## MATANUSKA-SUSITNA BOROUGH PLANNING COMMISSION AGENDA

October 21, 2024  
REGULAR MEETING  
6:00 p.m.

**Resolution 24-31** A Conditional Use Permit In Accordance With MSB 17.30 — Conditional Use Permit For Earth Material Extraction Activities, For The Extraction Of Approximately 7,500,000 Cubic Yards Of Earth Material From An Extraction Site Of 153 Acres Within Three Parcels Totaling 235 Acres On 7955 E. Bogard Road, 3182 N. Trunk Road, 7801 E. Glade Court, Tax ID#S 18N01E27A002, 18N01E27D001, 18N01E27D002. (Applicant: Dan Steiner, P.E. For Central Gravel Products; Staff: Peggy Horton, Current Planner)

Planning and Land Use Department  
Development Services Division  
Central Gravel Products – Gravel Pit - Application for Condition Use  
Response to MSB Comments

SHEET  
C0.1

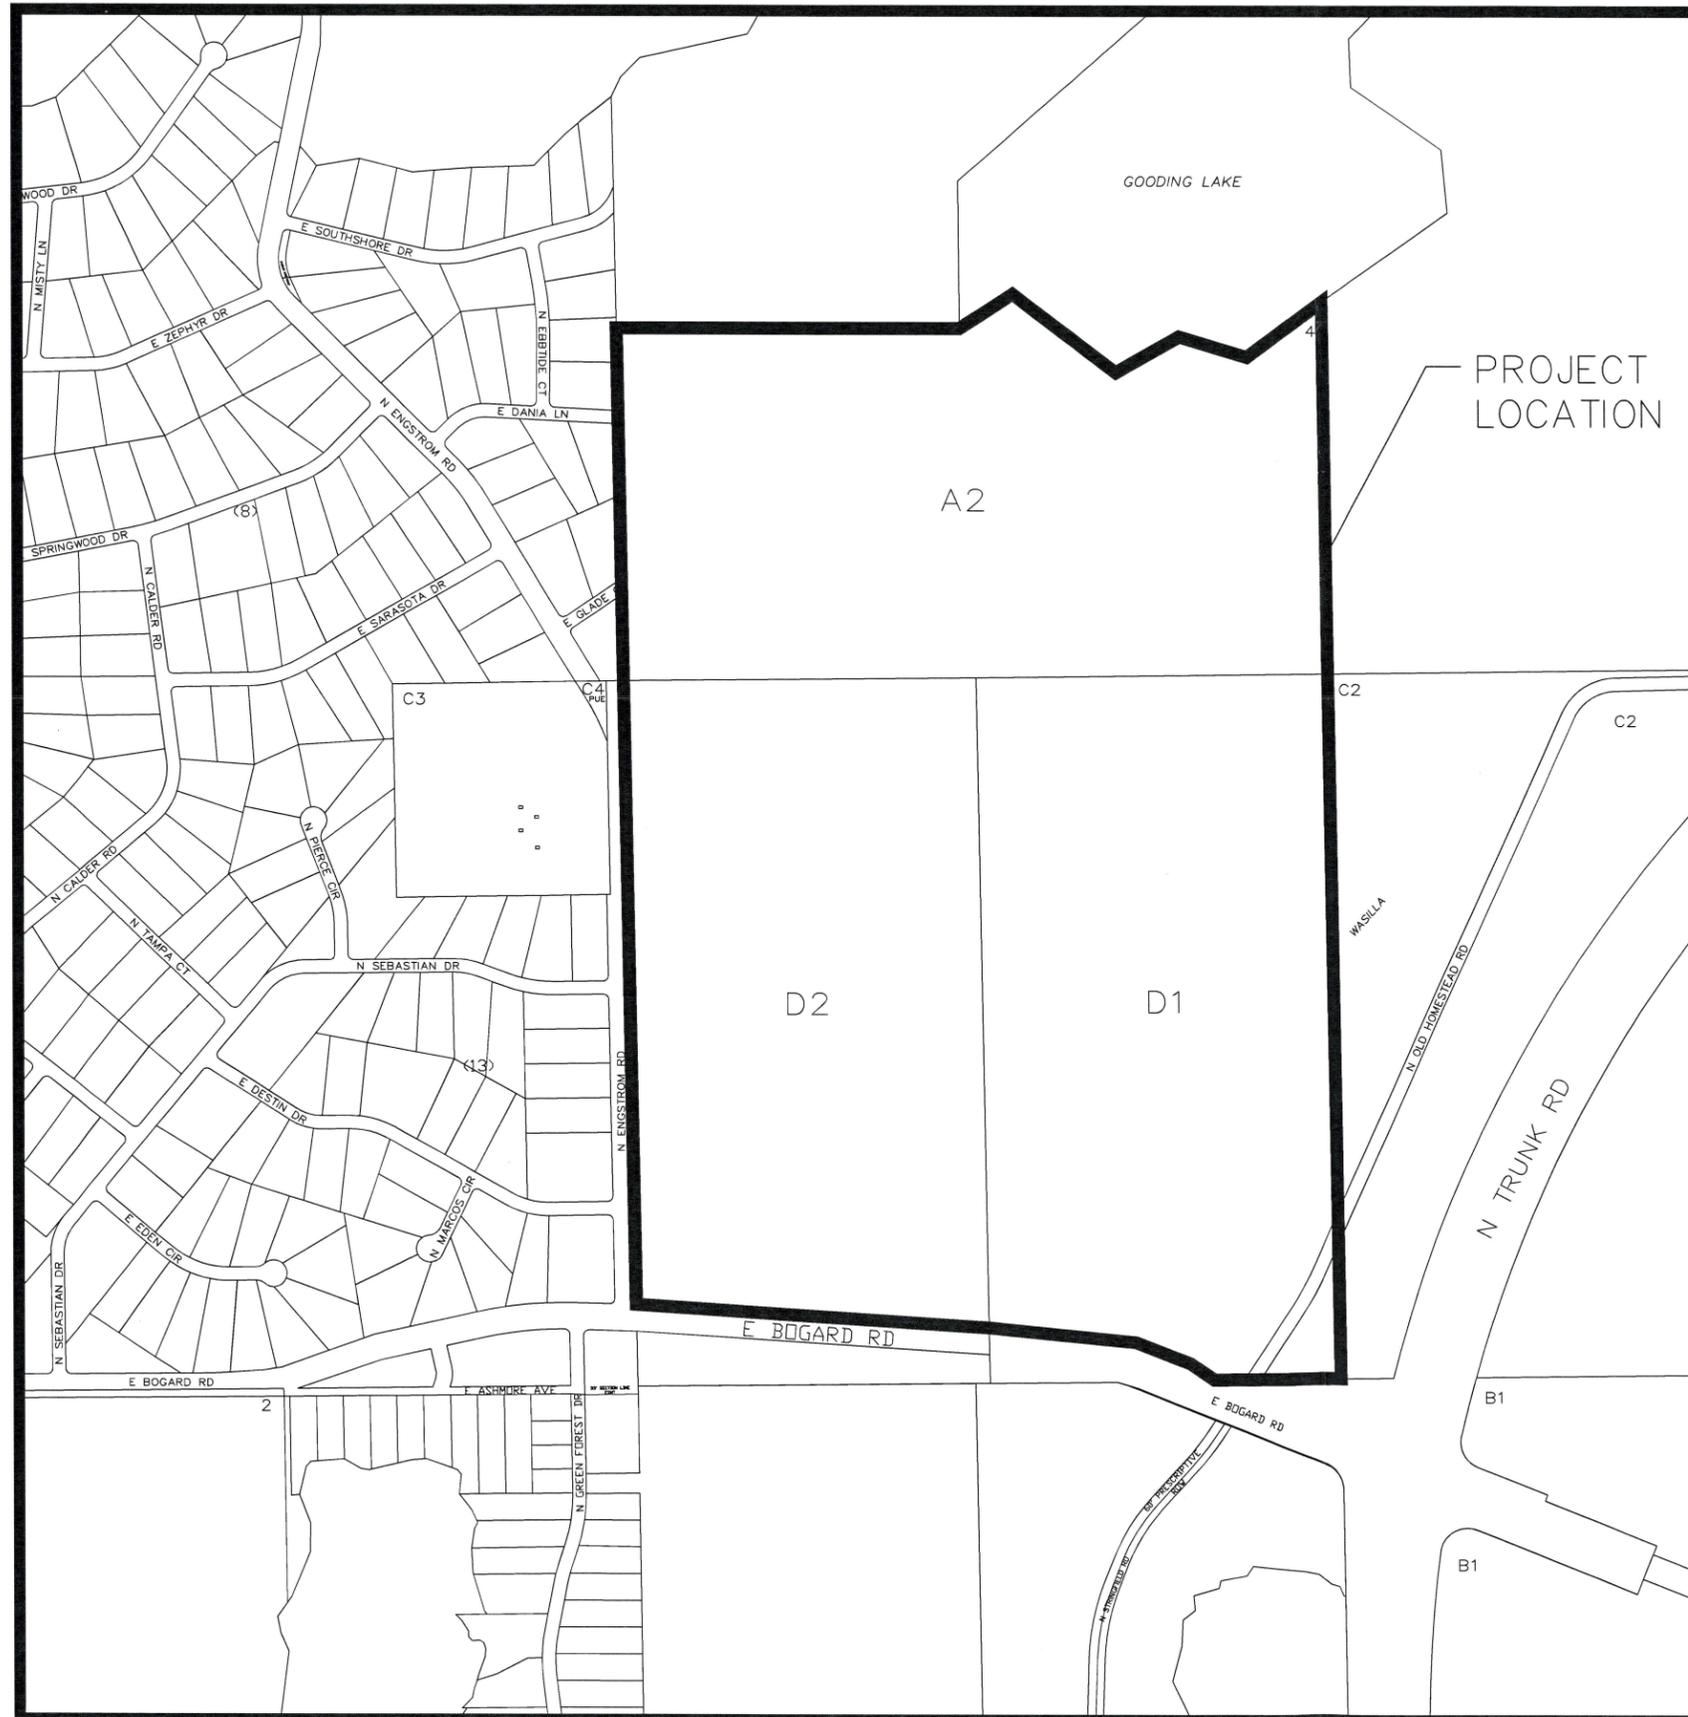
1. The southeast corner of the property boundary is shown incorrectly on the index sheet and sheets C0.1 and C0.2.  
**Corrected. Updated sheet included with this letter.**

SHEET  
C1.2

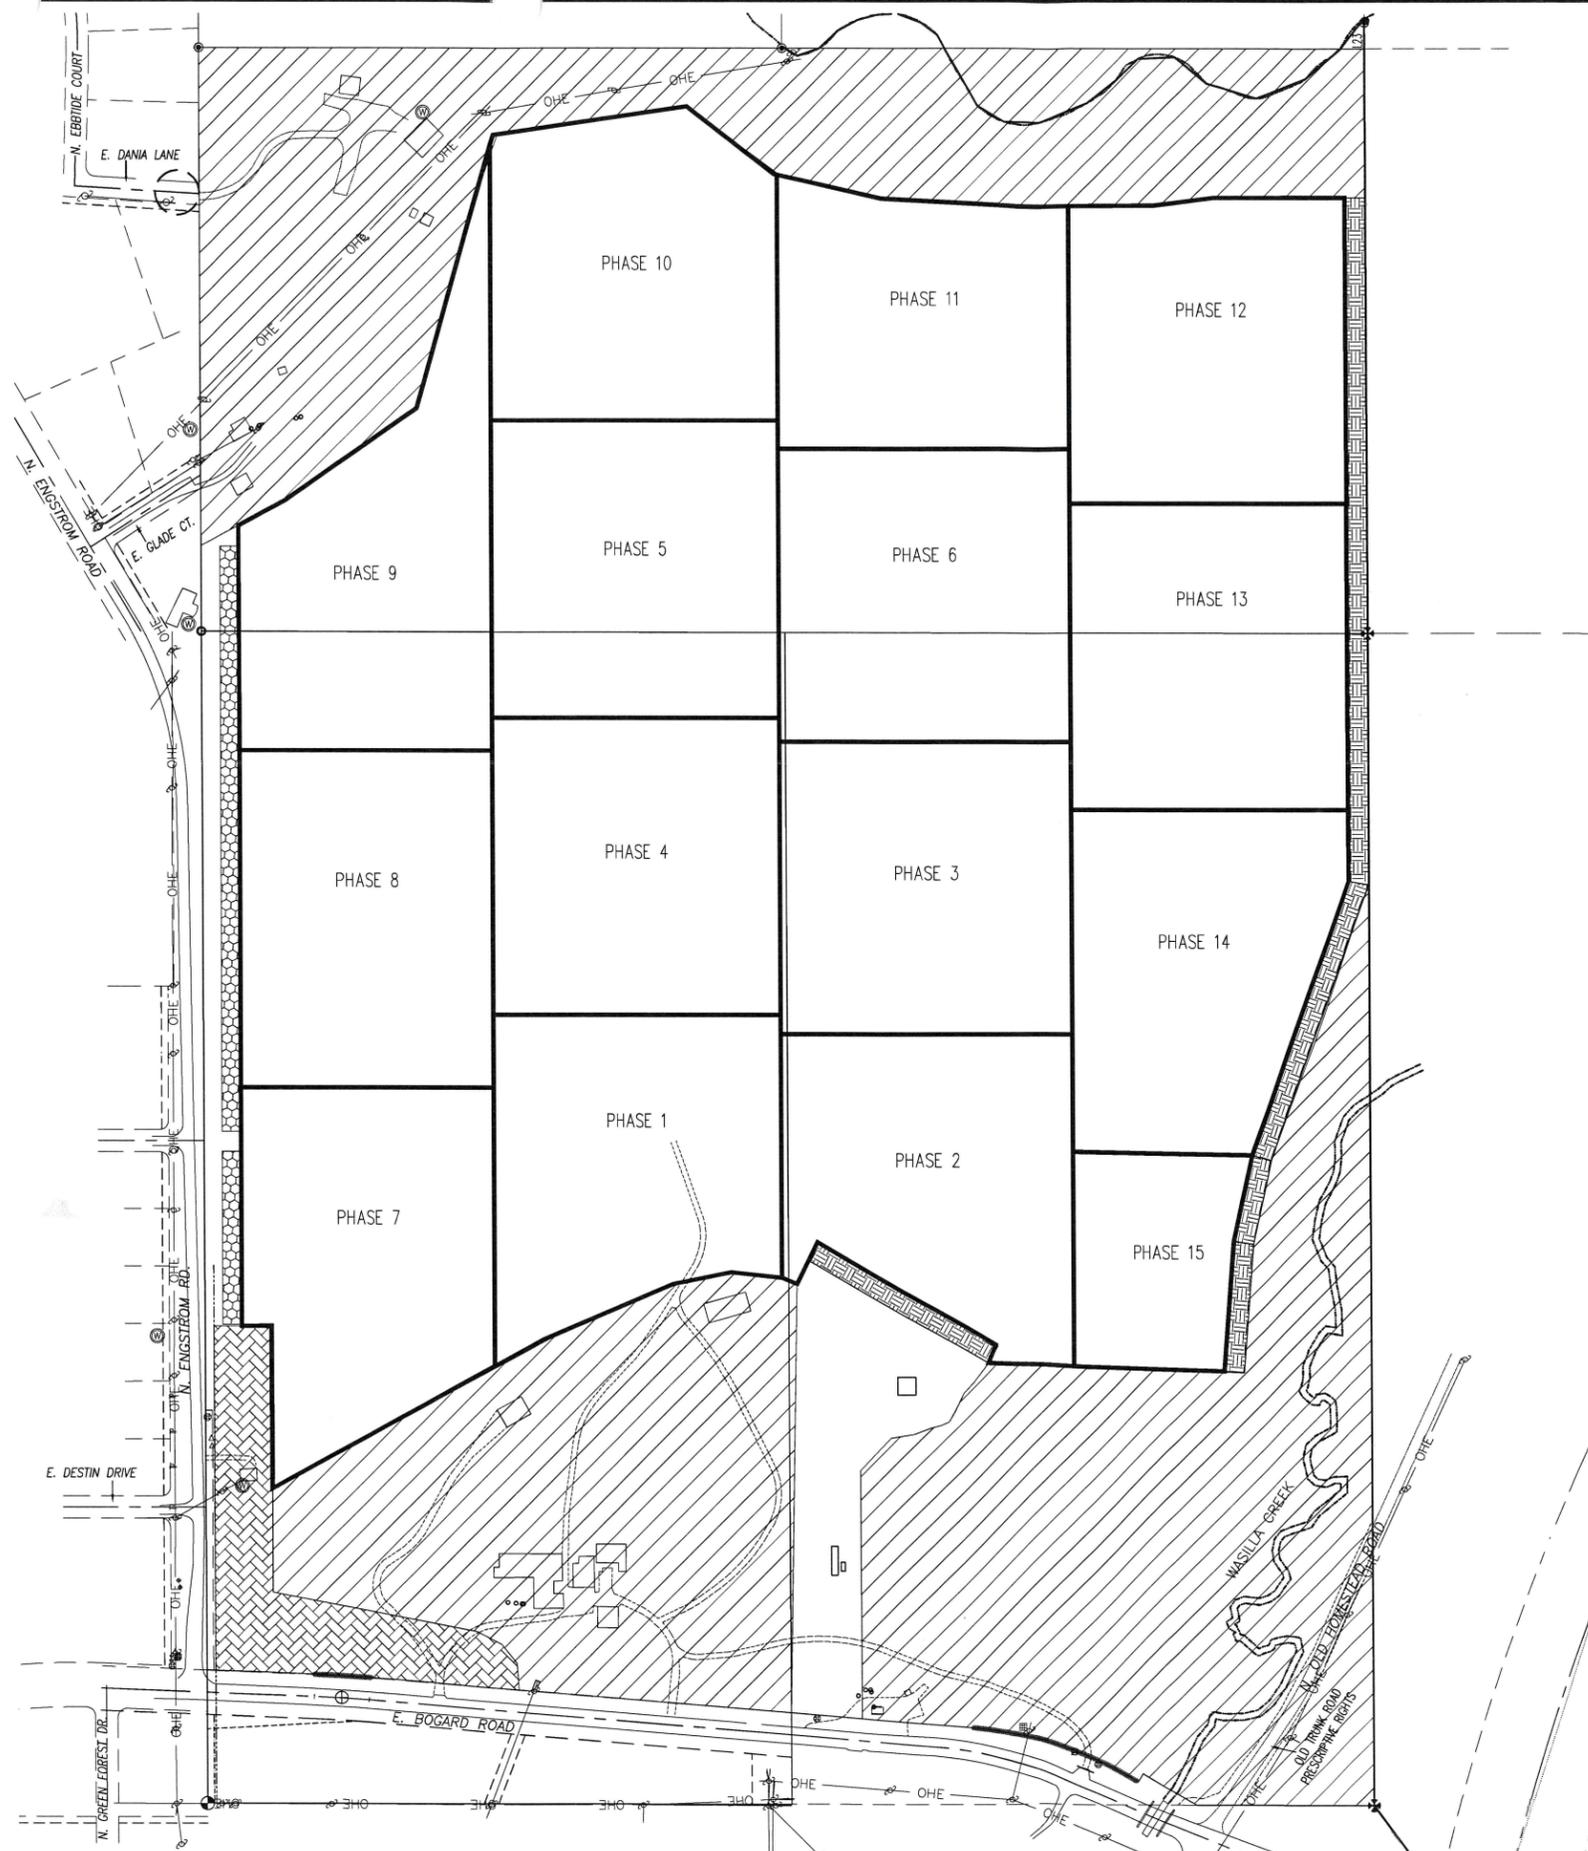
2. The site plan contains some misspellings that could be confusing.
  - a. On sheet C1.0, Note 2, line 1, replace “being” with begin.
  - b. On sheet C1.2, Note 1, remove the first instance of “are.”

- c. On sheet C1.2, Note 3, replace “ares” with areas and “move” with more.  
**Typos corrected.**
3. The site plan, Sheet C1.0, has an extra internal line that clutters the sheet; please remove it. I’ve attached a redlined copy.

SHEET  
C2.0

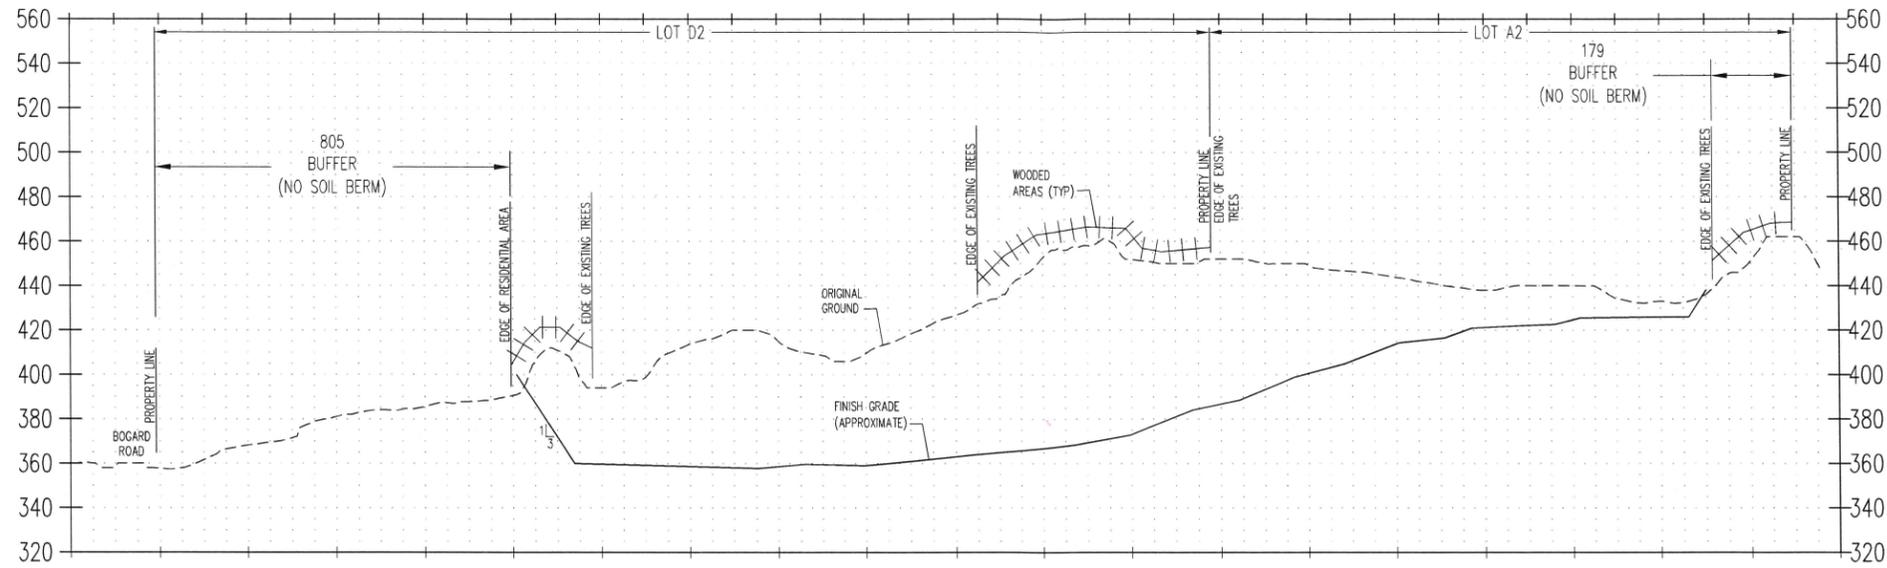
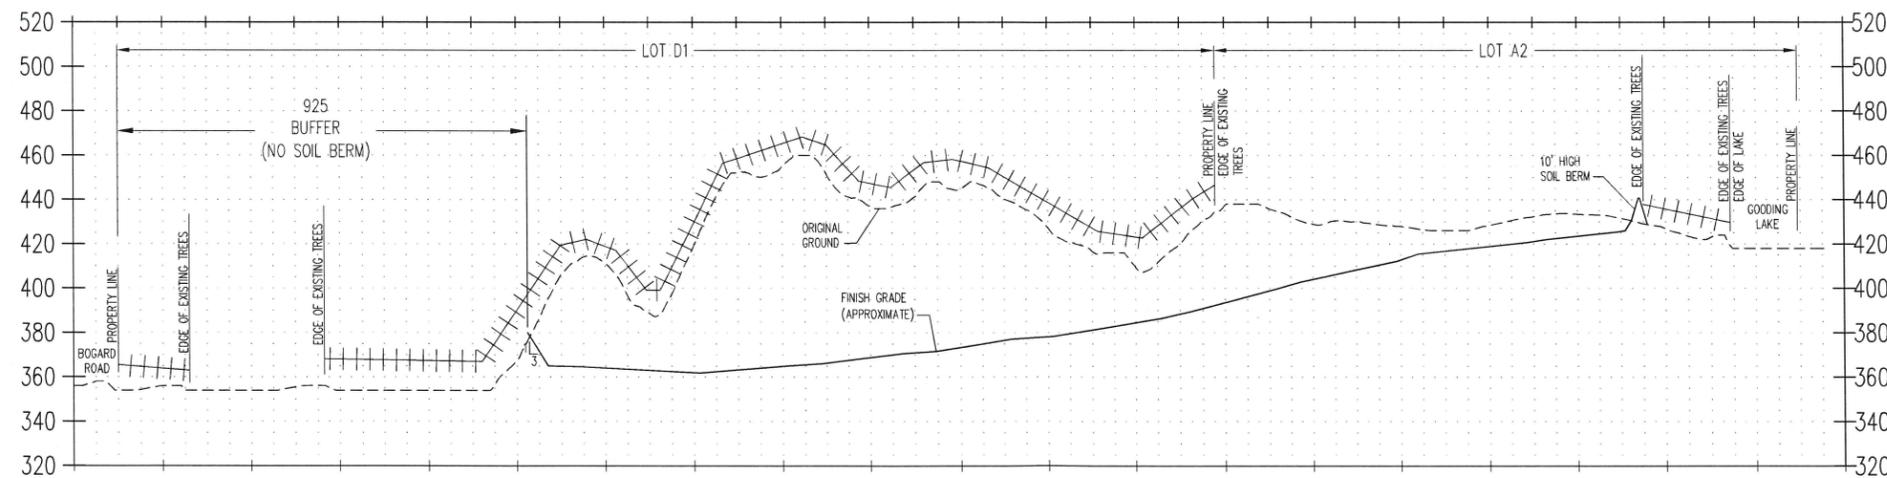
7. The site plan, Sheet C1.0, is missing the symbols for the cross-section lines A and B.

Corrected. Updated sheet included with this letter.

SHEET  
C2.1

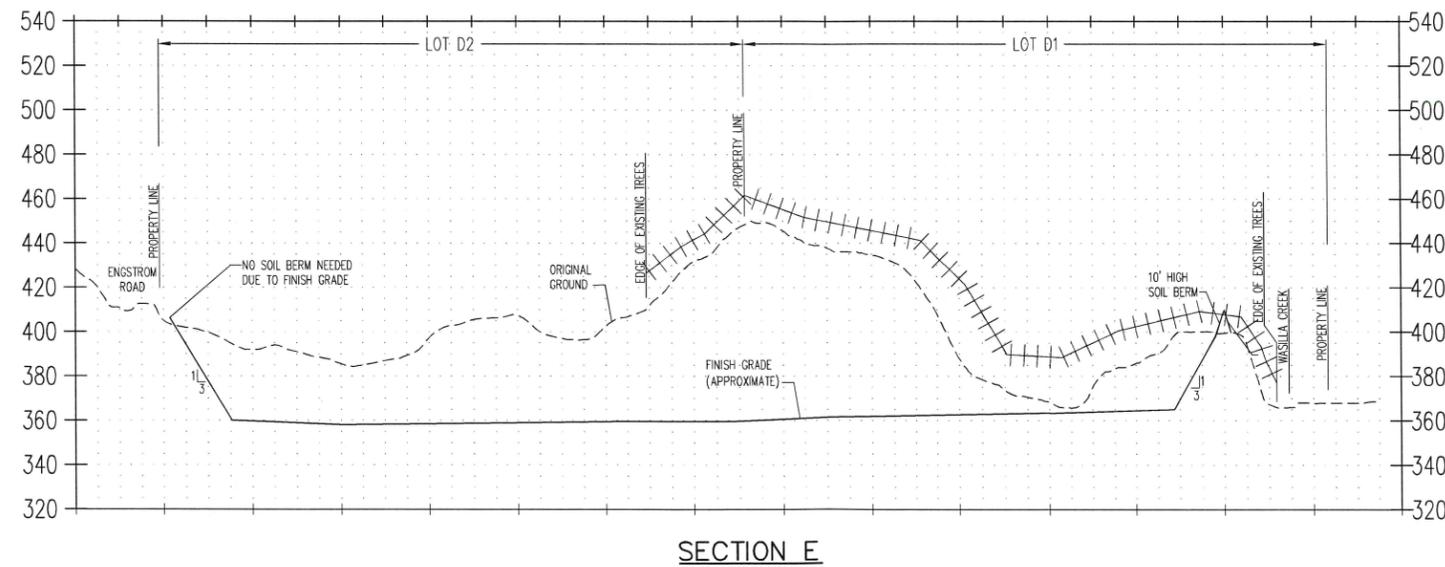
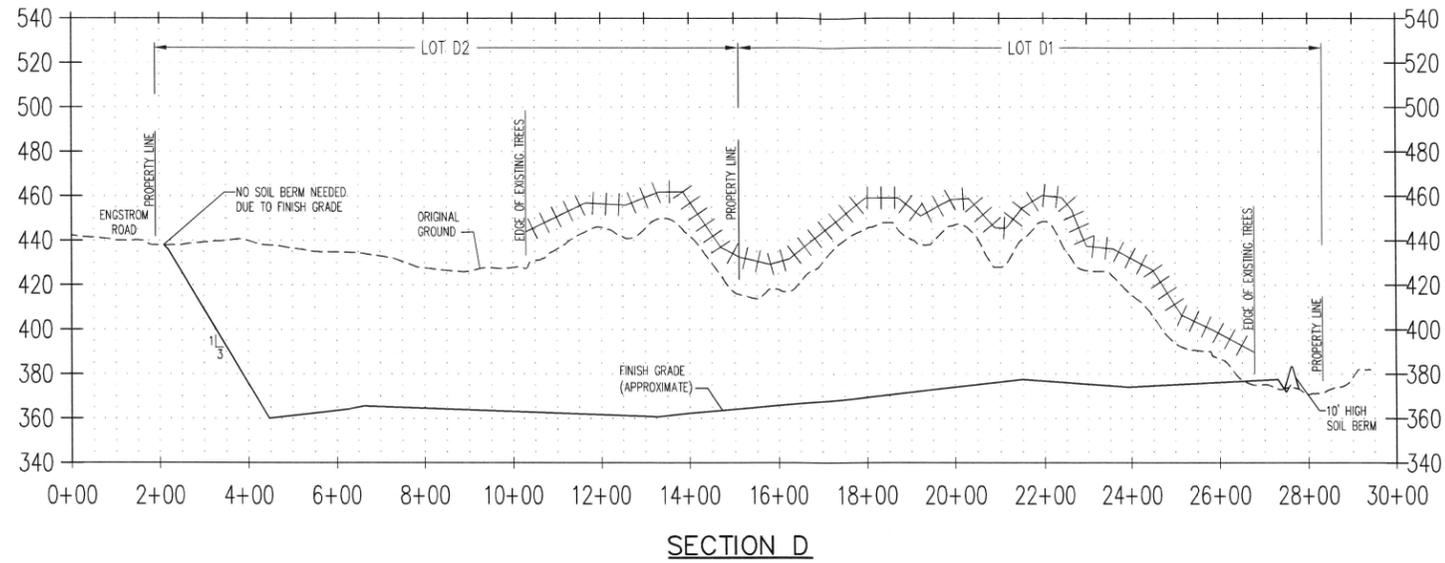
In our discussion with the MSB, the MSB expressed concern about drifting snow along Engstrom Road and the increase in drifting that a 10' high soil berm would cause. With the existing topography and the plan to begin material extraction at the lower elevations of the site, a 10' high soil berm along Engstrom Road will not be needed. See section D/C2.1 for visual explanation.
